STRUCTURAL – ADDENDUM 1

July 22, 2026 **Project Number:** 21032

Project Name: The Sterling Hall School

The following are changes to the tender documents and are effective immediately. This addendum forms part of the contract documents issued previously. All changes are clouded in drawings.

1 S401 SW1 ELEVATION
1 : 50

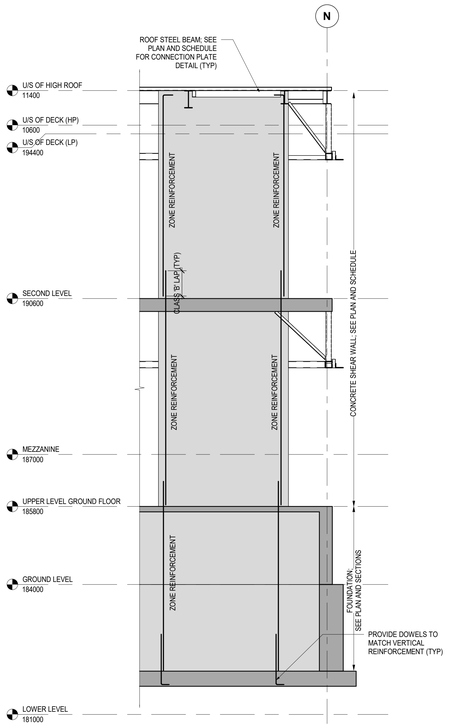
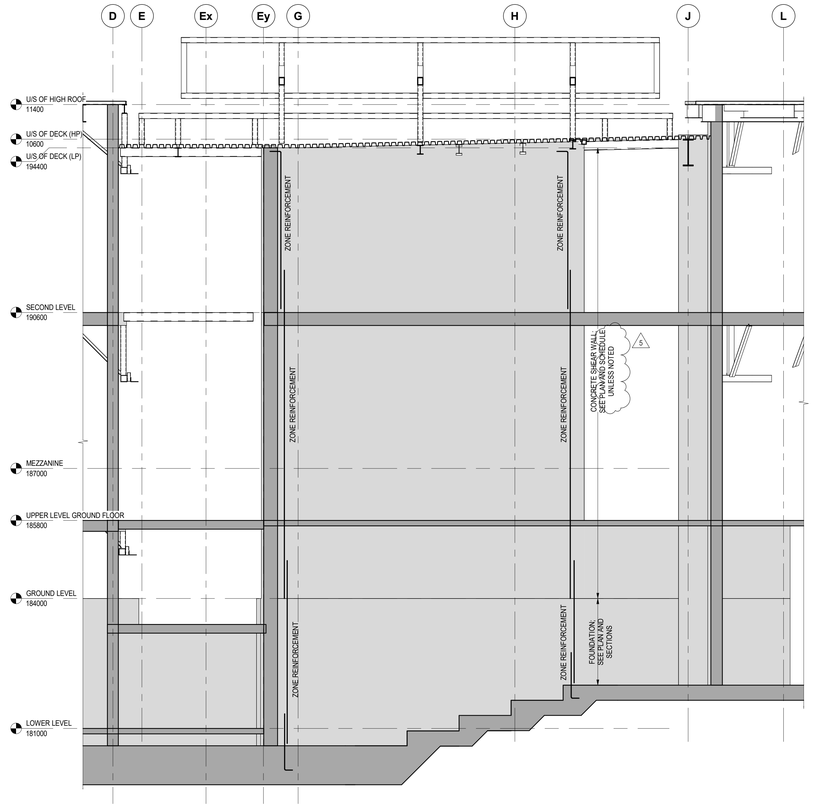
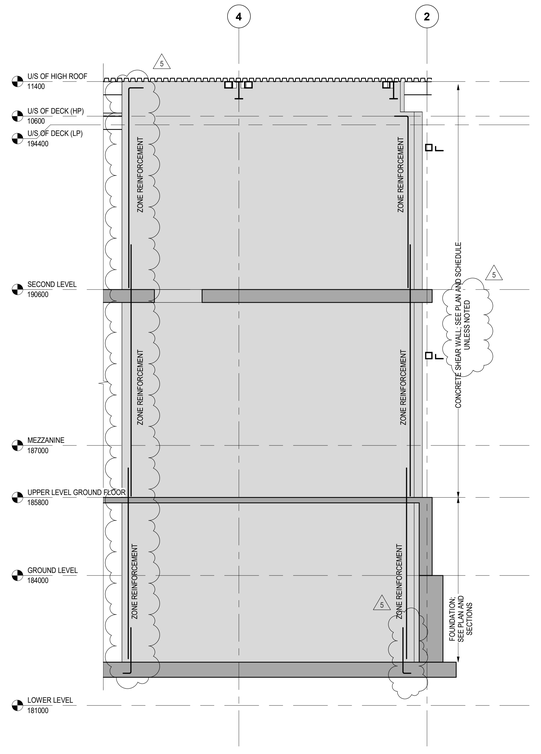
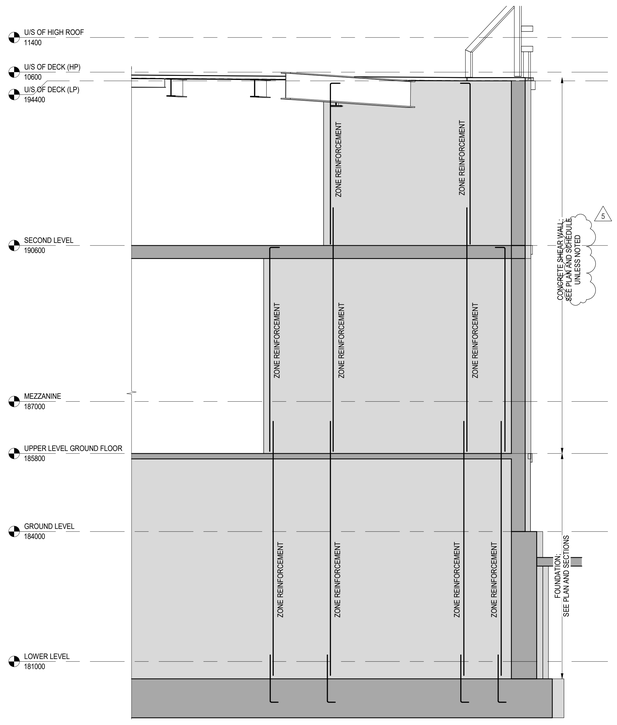
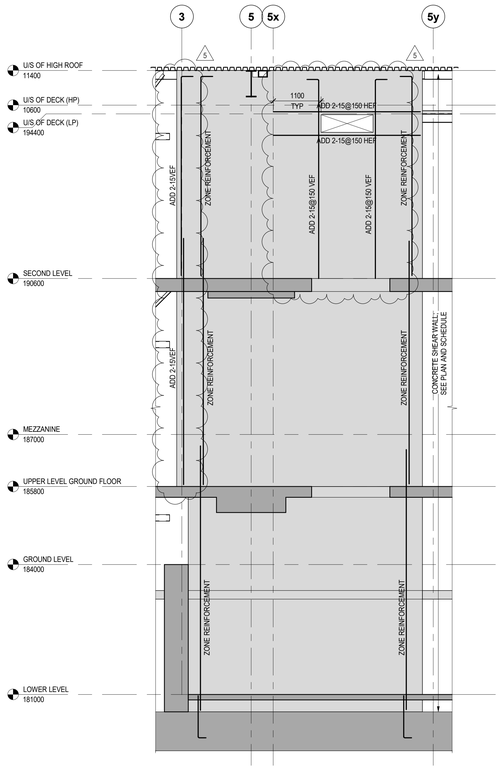
2.8.1 Revised and added elevations

2.8.2 Revised reinforcement

1 S410 ELEVATION
1 : 50

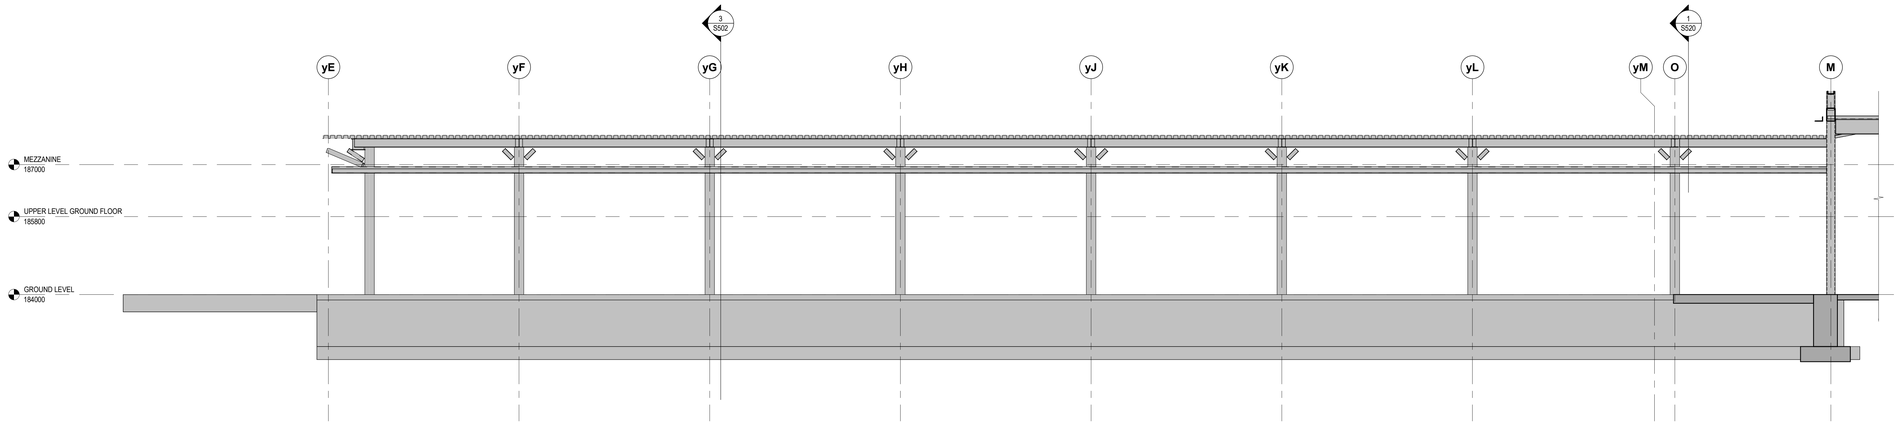
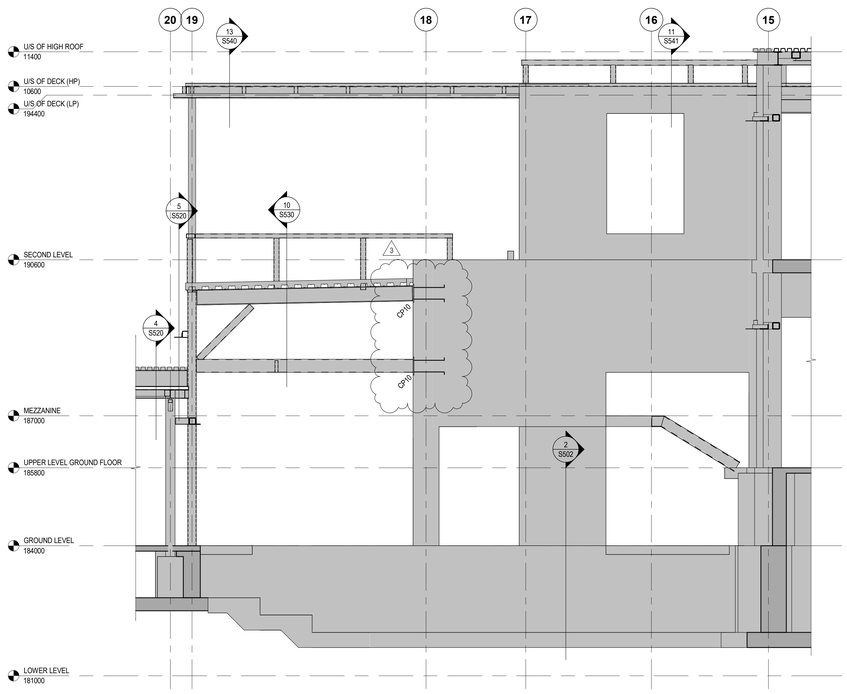
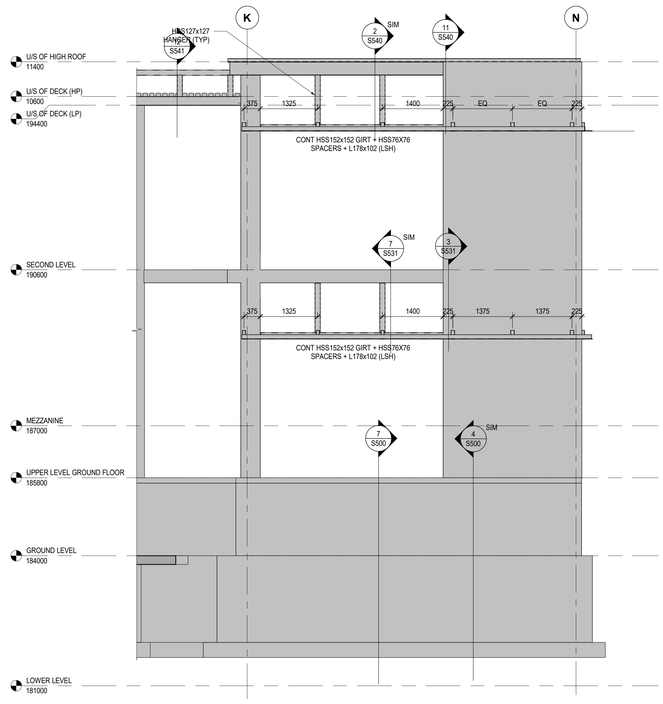
2.9.1 Added/revised connection plate and structural steel framing

1 S500 SECTION 1 : 20

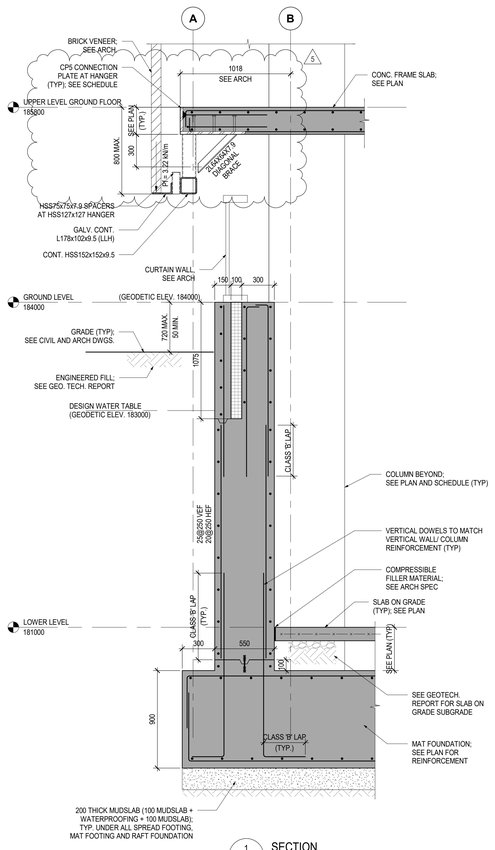
2.10.1 Revised and/or added Section 1/S500, 4/S500, 5/S501, 6/S501, 2/S502, 2/S503, 3/S503, 8/S503, 10/S503, 5/S510, 3/S511, 4/S511, 5/S511, 6/S511, 7/S511, 2/S521, 4/S521, 3/S530, 4/S530, 5/S530, 7/S530, 11/S530, 12/S530, 1/S531, 8/S531, 9/S531, 10/S531, 12/S540, 10/S541, 11/S541, 12/S541

3 S600 SECOND FLOOR - STAIR PLAN
1 : 50

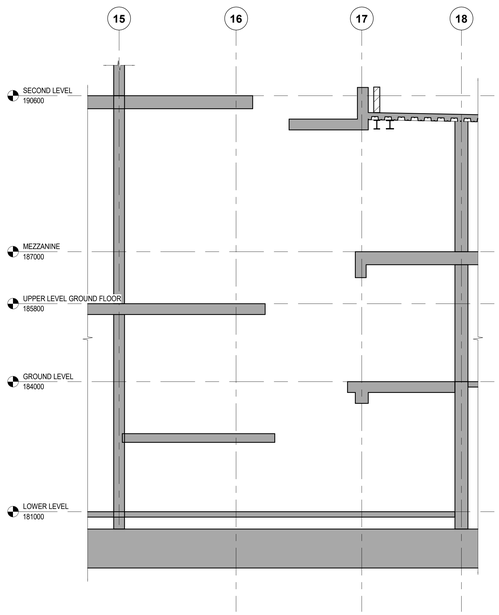
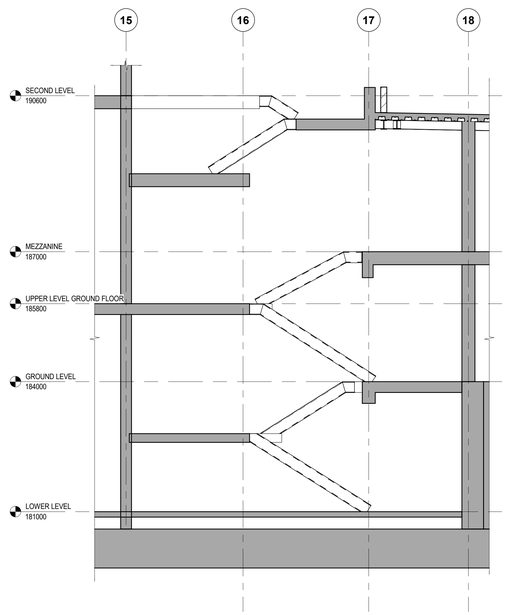
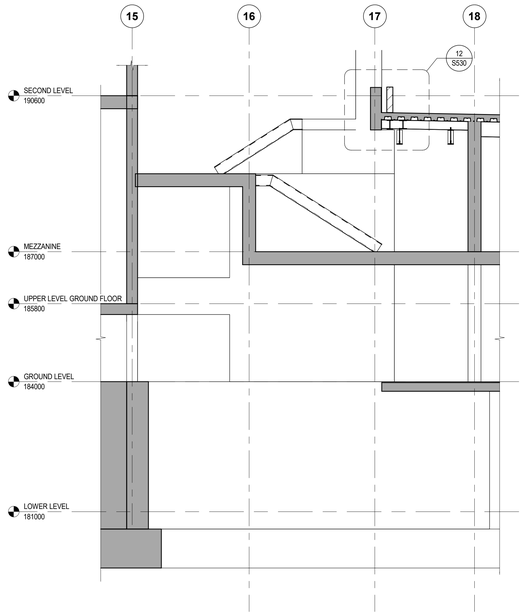
2.11.1 Revised reinforcement and elevations for the stairs
